# **SEC Modification Proposal, SECMP 0038**

## **Sending Commands via PPMIDs**

### **DCC Preliminary Impact Assessment (PIA), DCC CR 280**

**8 August 2018**

Figure 1: Potential Conceptual Architecture for This Modification

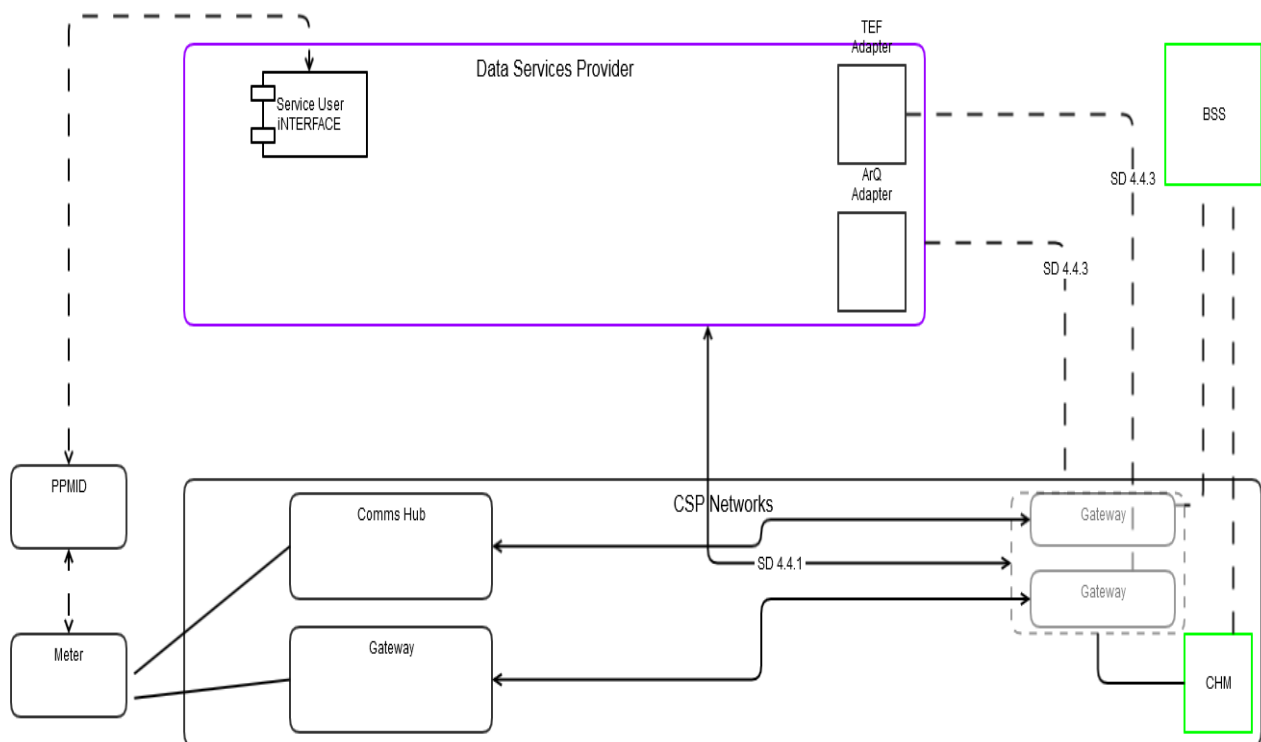
In the currently defined Service User Service Request flow, the Data Service Provider sends a Service Request (SR) through the SM WAN Gateway and the same is sent to the Communications Hub across the CSP network. This Modification is focused on a situation where the SM WAN is deemed not responsive or intermittent, and in this case the Service Request will be passed through the PPMID so that it will bypass the SM WAN Gateway.

However, any responses from a meter related to the Service Request are expected to travel through the current Communications Hub and then the SM WAN route. This Modification and the change to response routing will have an impact on the current CSP business support processes for billing and performance reporting. To use the current reporting framework, it is proposed that the DSP will pass the log files periodically to the CSP for the Service Requests that passed through PPMID connected with the respective CSP Communications Hubs.
